The **7abc** HOTEL
OFFICE

Planning Objection
Responses

ambigram architects

Second Floor:

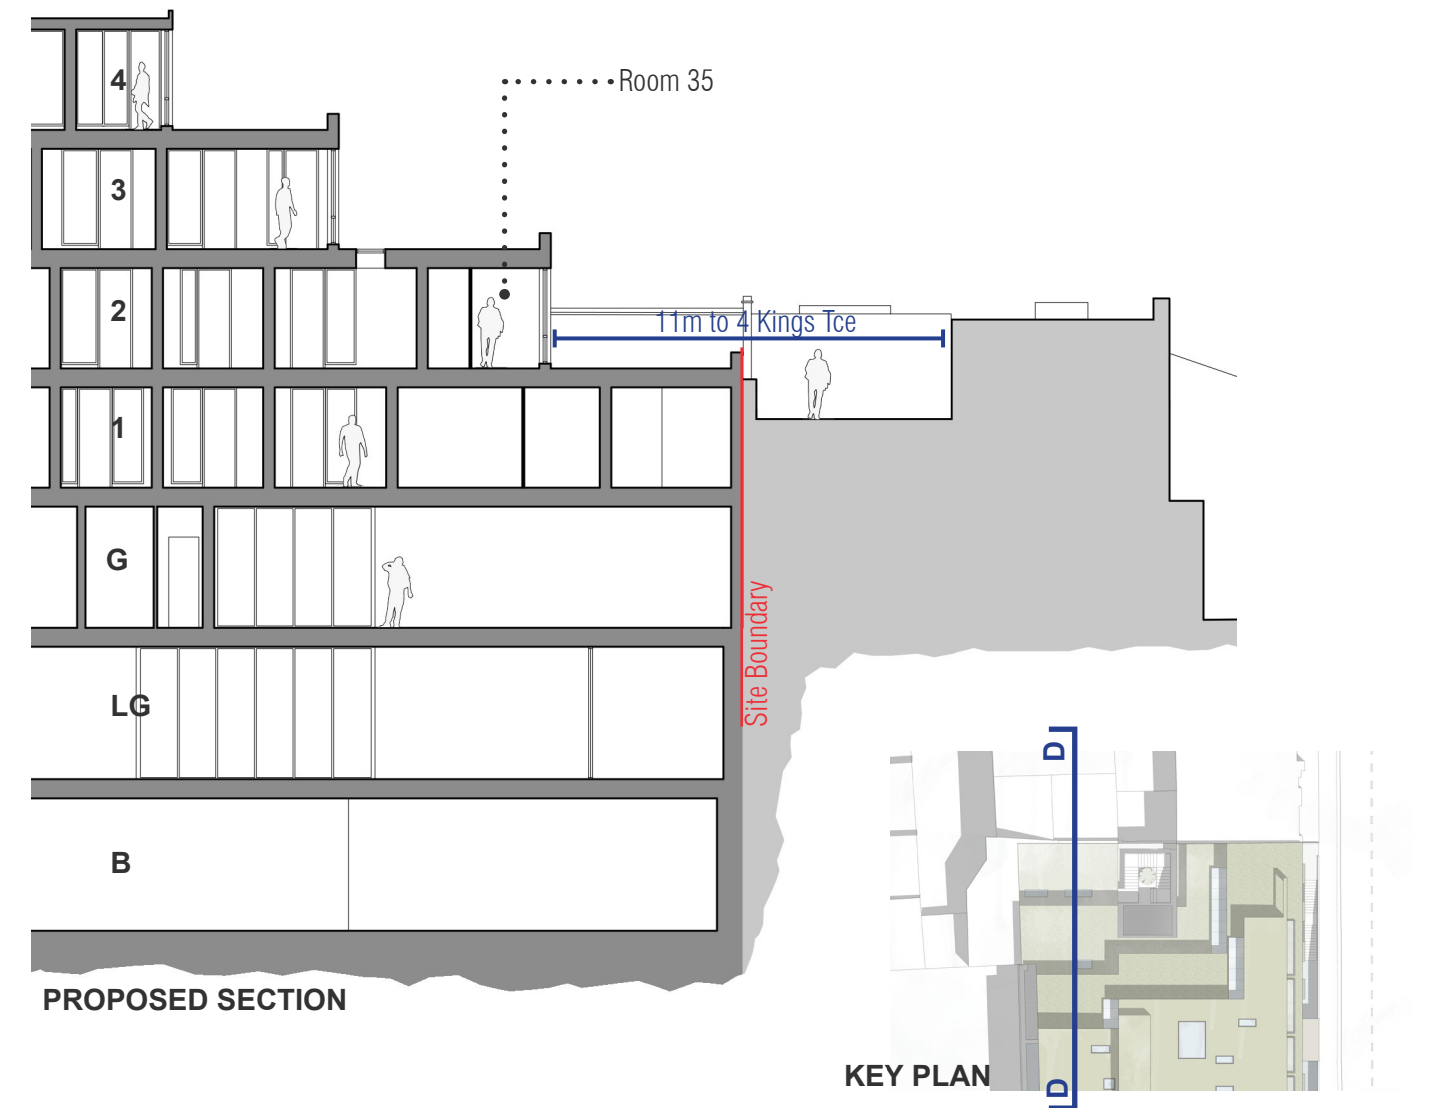
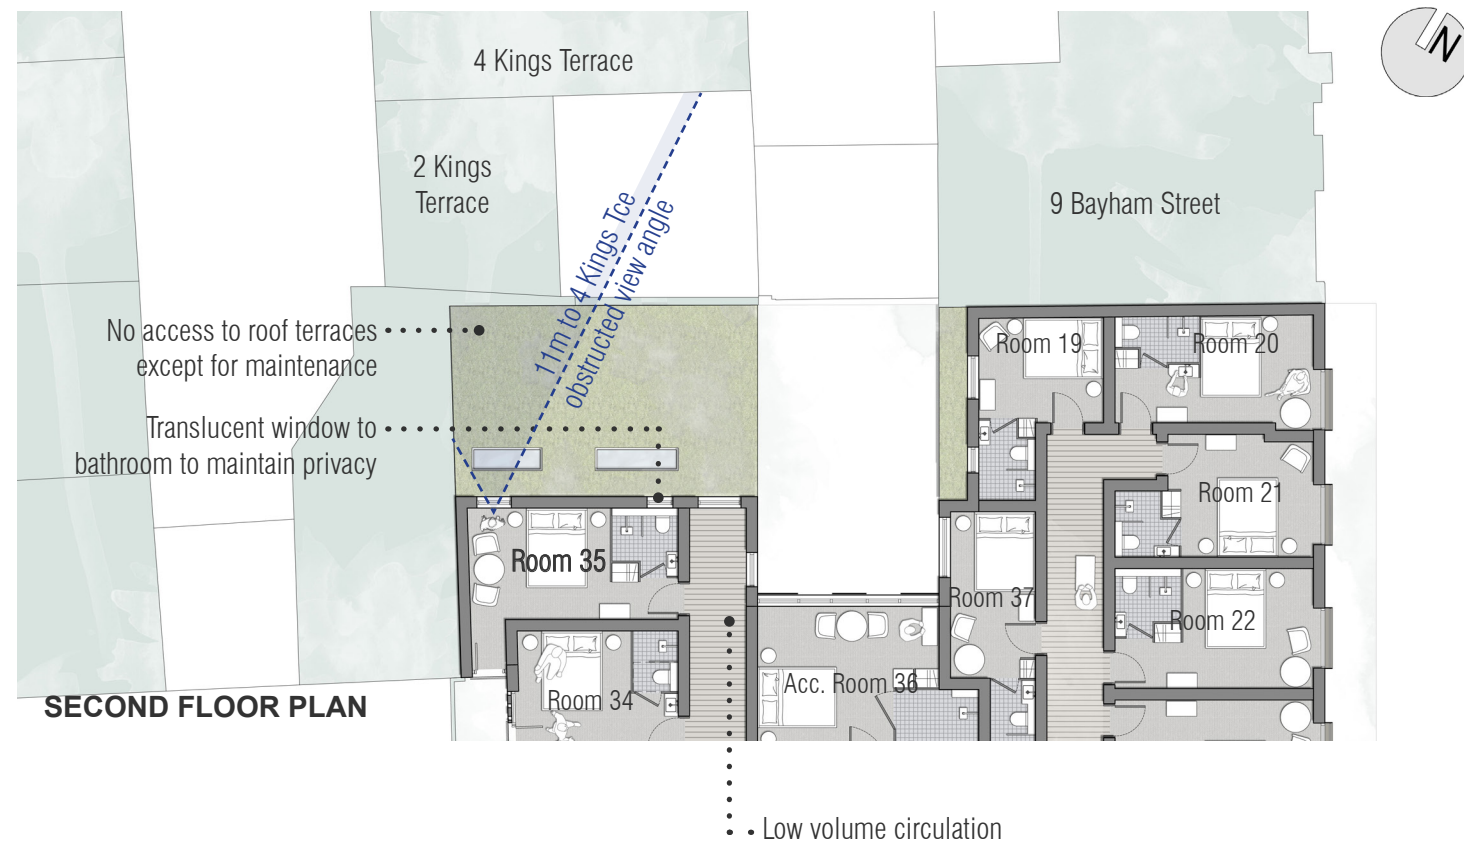
• *Windows are incorporated at the second floor northern elevation (Room 35) together with a northern-facing terrace feature, which directly overlooks the rear of the properties at Bayham Street and those within King's Terrace.*

- The glazing from rooms 35 will be approx. 11m from the glazing of 4 Kings Terrace and 14m from the rear of Bayham Street with oblique views only.
- This is a greater separation distance than those of existing windows to the northern elevation of the office building at 7a Bayham Street.
- A 375mm parapet wall and landscaping on the roof terrace will restrict overlooking.
- The directly overlooking bathroom window will have translucent glazing to allow light and ventilation whilst maintaining mutual privacy with no overlooking.
- The landscaped roof terraces will be for visual amenity only with no access for guests.

Second Floor:

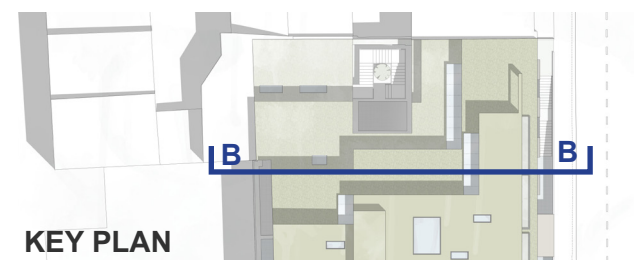
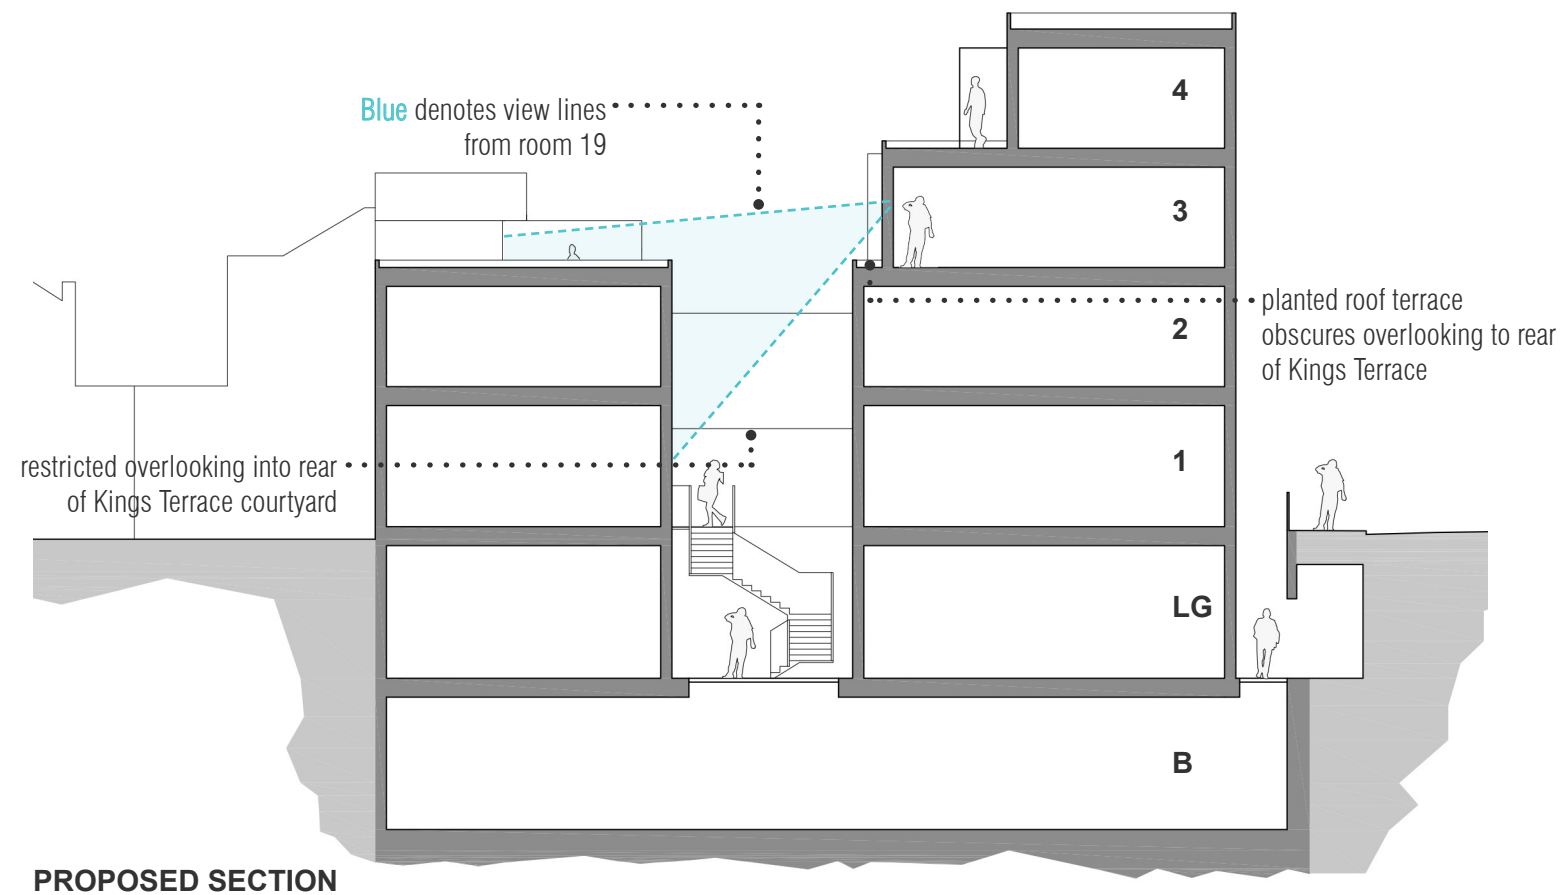
- A small terrace feature and windows also give rise to issues of overlooking and loss of privacy from proposed Room 19.
- The landscaped roof terrace in front of room 19 will be for visual amenity only with no access for guests.
- The glazing from rooms 19 will be approx. 12m from the glazing of 4 Kings Terrace, with oblique views only.
- This is a greater separation distance than those of existing windows to the northern elevation of the office building at 7a Bayham Street.
- A 375mm parapet wall and landscaping on the roof terrace will provide visual screening and restrict direct overlooking.
- The bathroom window will have translucent glazing to allow light and ventilation whilst maintaining mutual privacy with no overlooking.

Third Floor:

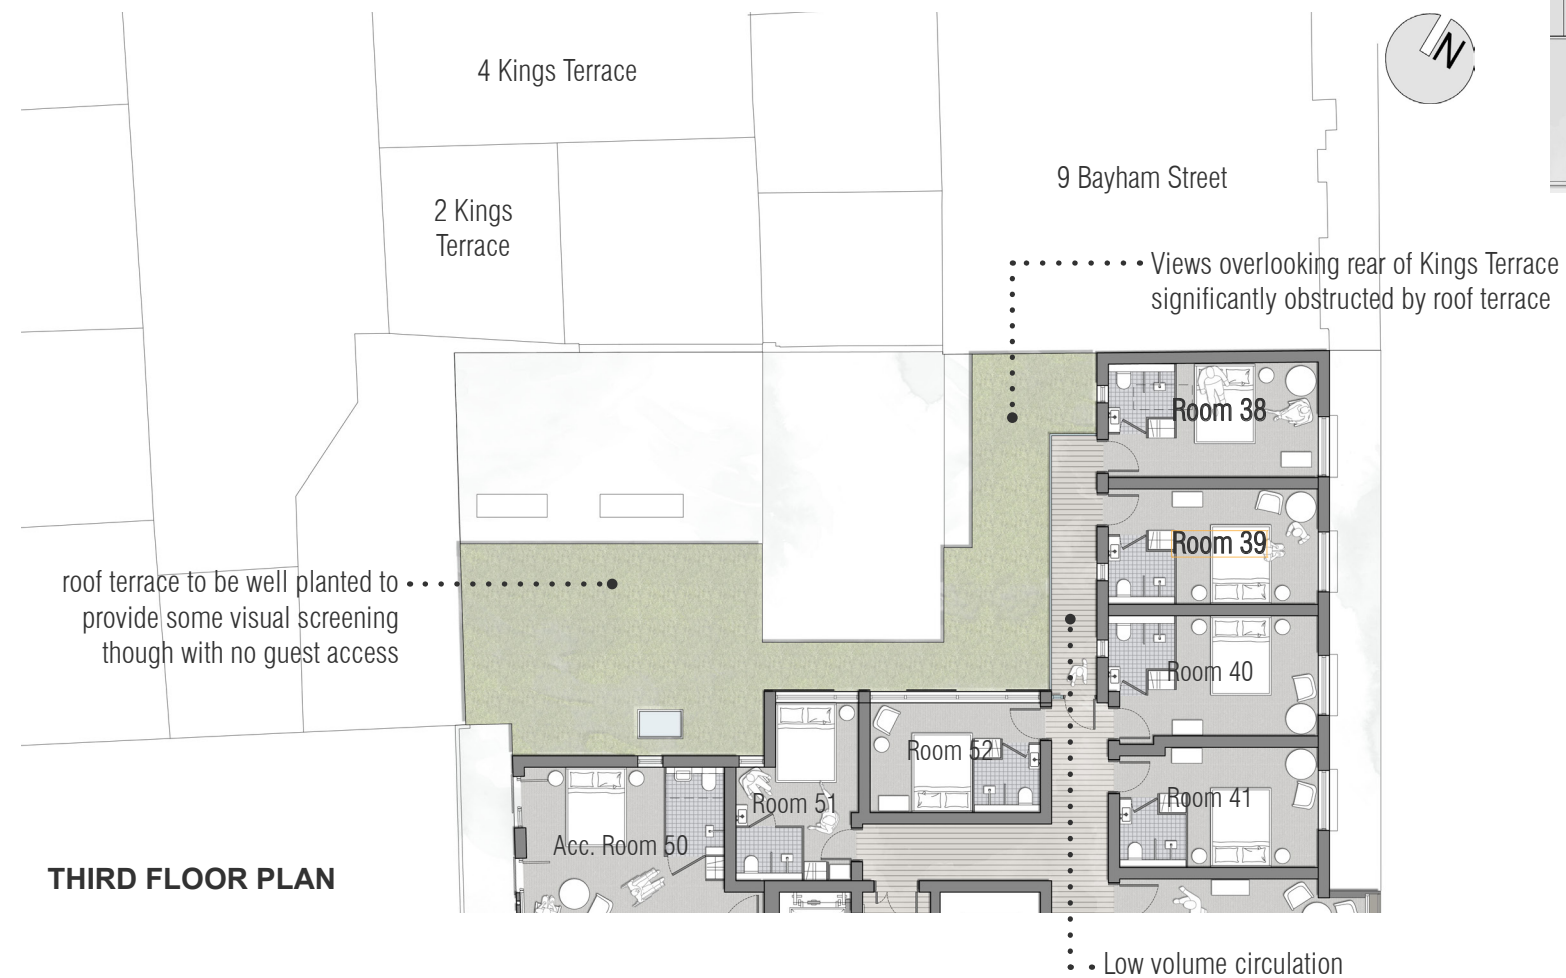
• A significant glazed link providing circulation for hotel guests is proposed which directly overlooks properties at the rear of Bayham Street and within Kings Terrace (associated with Rooms 38 and 39).

- The glazed link serves two rooms only and will be low volume circulation with infrequent use throughout the day.
- This link is set back significantly from the parapet line obscuring any view into the courtyard of the rear of Kings Terrace.
- Planting on the roof terrace level will provide some additional visual screening from the glazed link.

Third Floor:

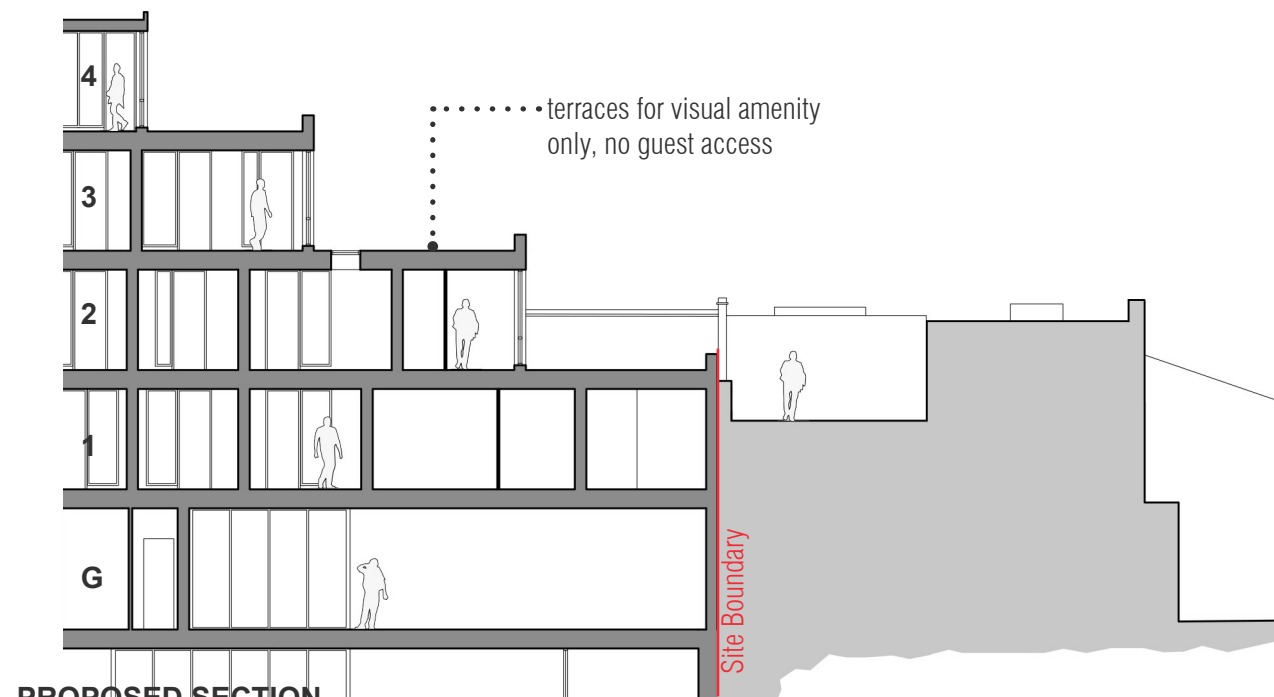
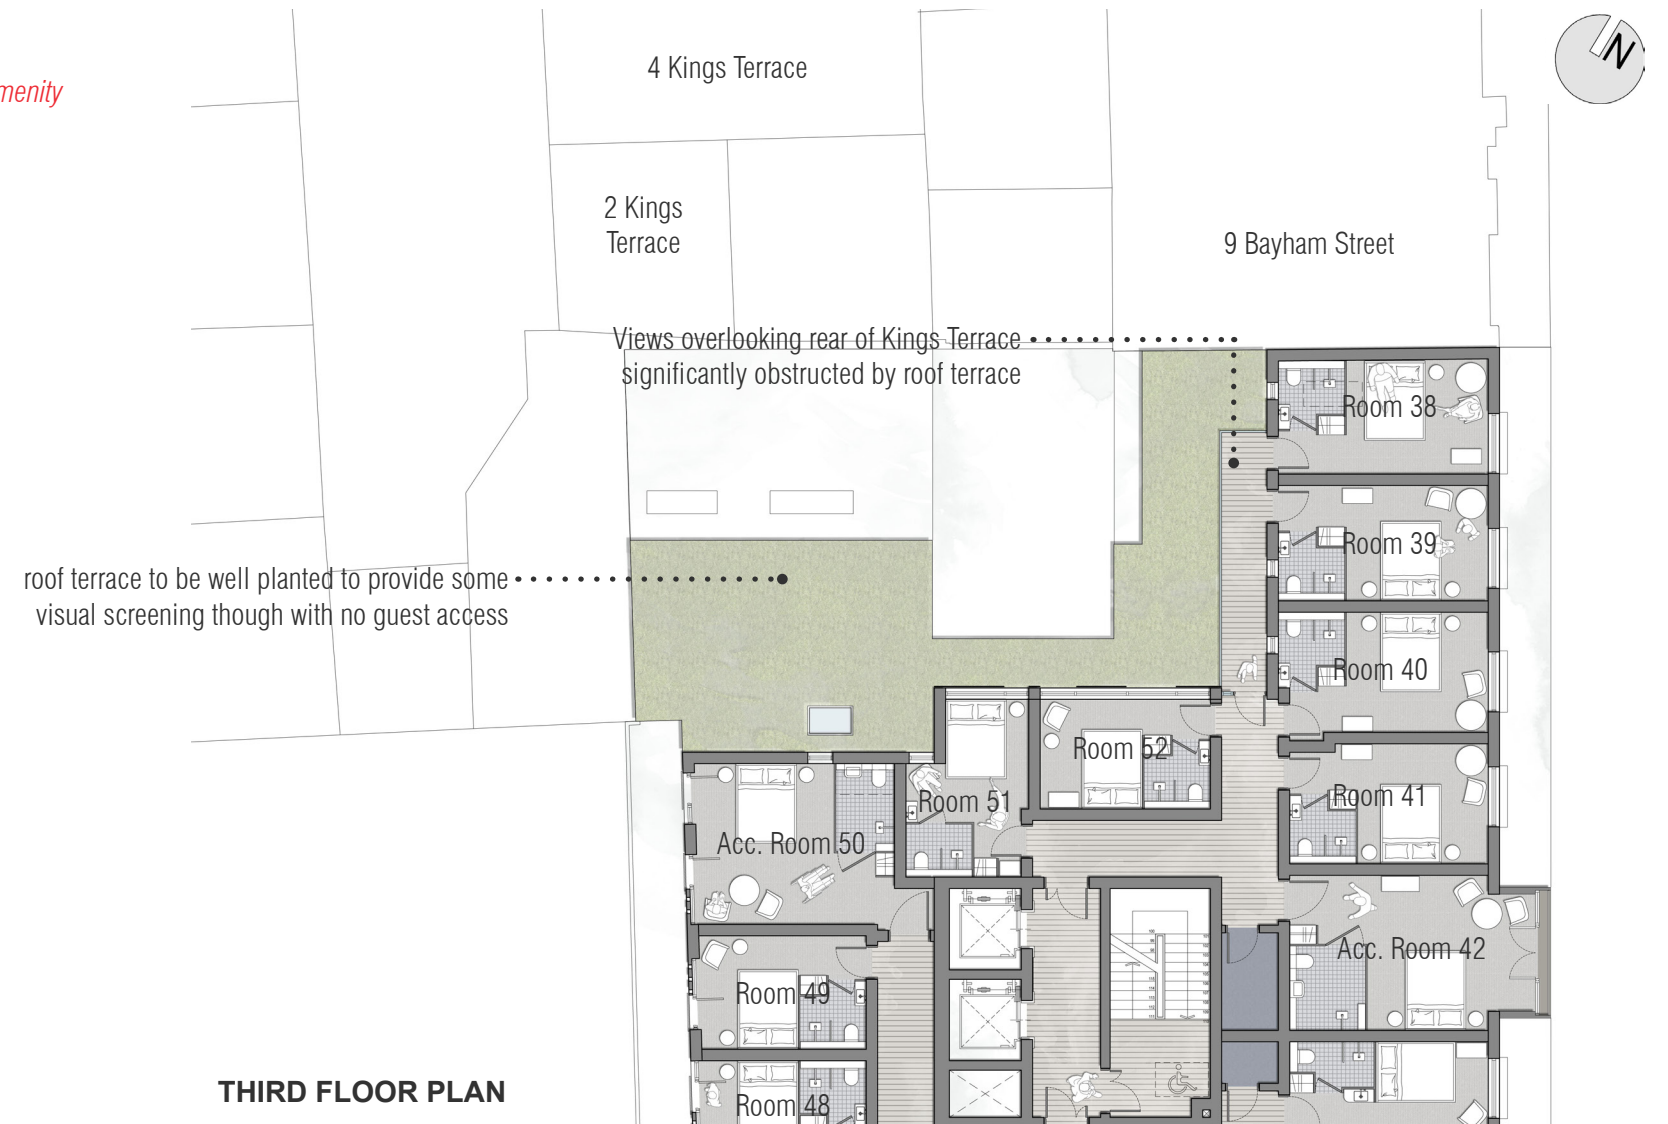
• *The incorporation of a planted roof terrace to entirety of the northern elevation. It is not clear whether these terraces would as amenity spaces for the enjoyment of hotel guest. Again, the submission package is vague on details - we would hope unintentionally.*

- The roof terraces will not be accessible to hotel guests.
- Terraces to provide visual amenity only and some screening against overlooking.

Fourth Floor:

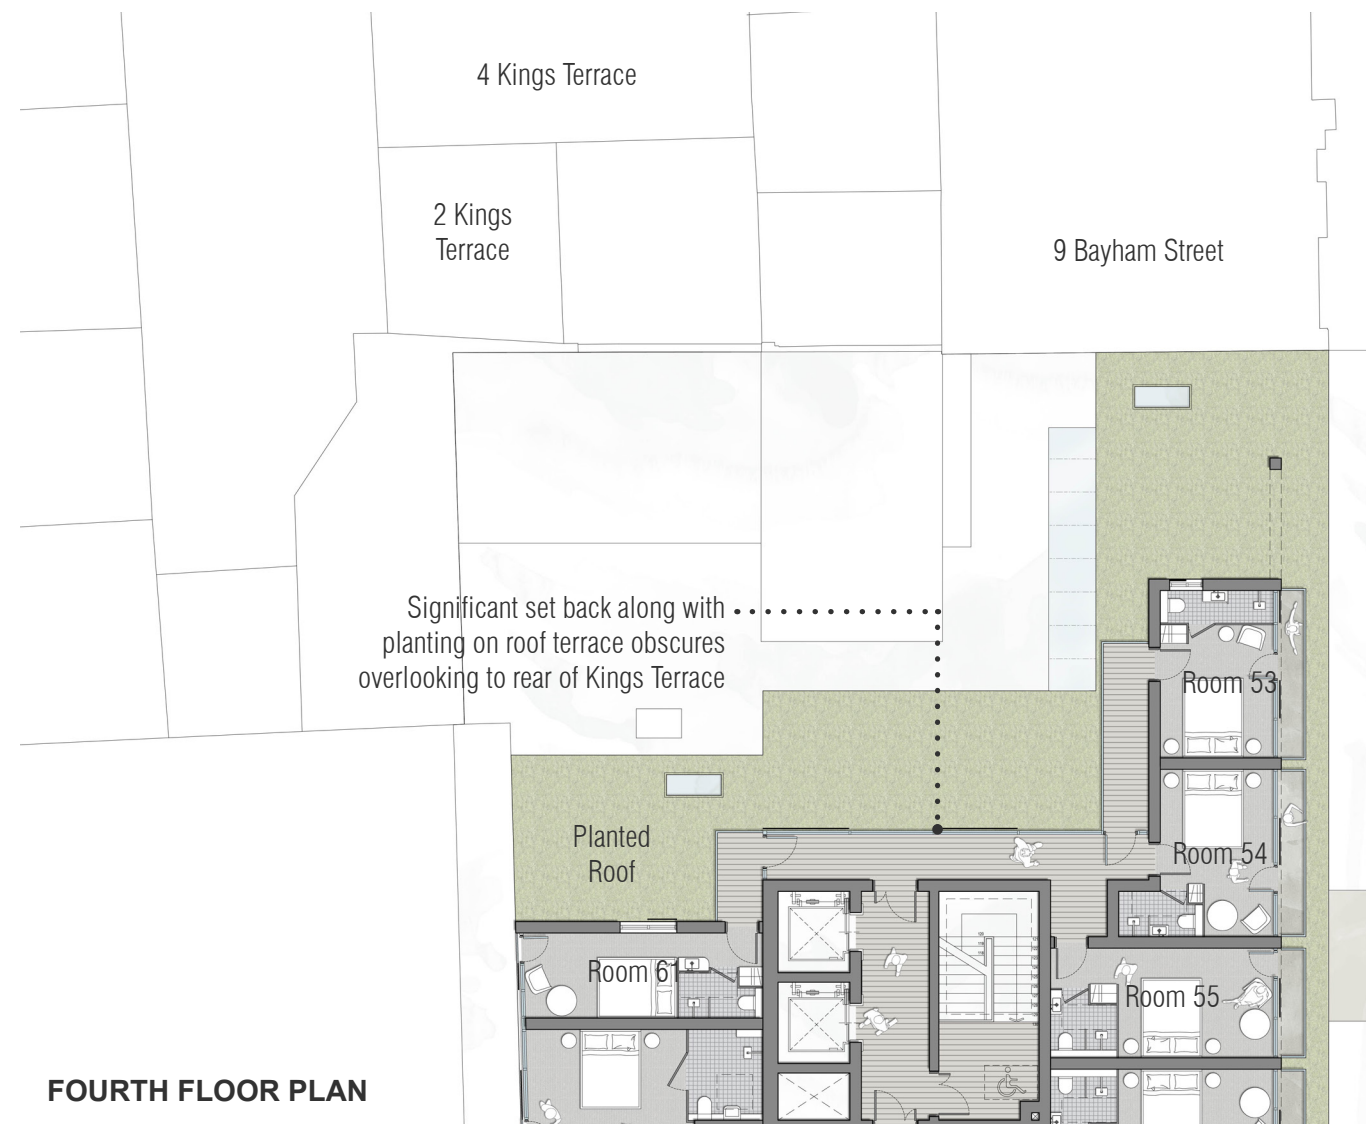
• A significant glazed link providing circulation for hotel guests is proposed which directly overlooks properties at the rear of Bayham Street and within Kings Terrace. This provides access to Rooms 53 and 54, and functions as a communal area along most of the northern aspect

- The glazed link along the north elevation provides access to four rooms only and will be low volume circulation with infrequent use throughout the day.
- The significant set back will substantially reduce or eliminate altogether any overlooking from the glazed link.
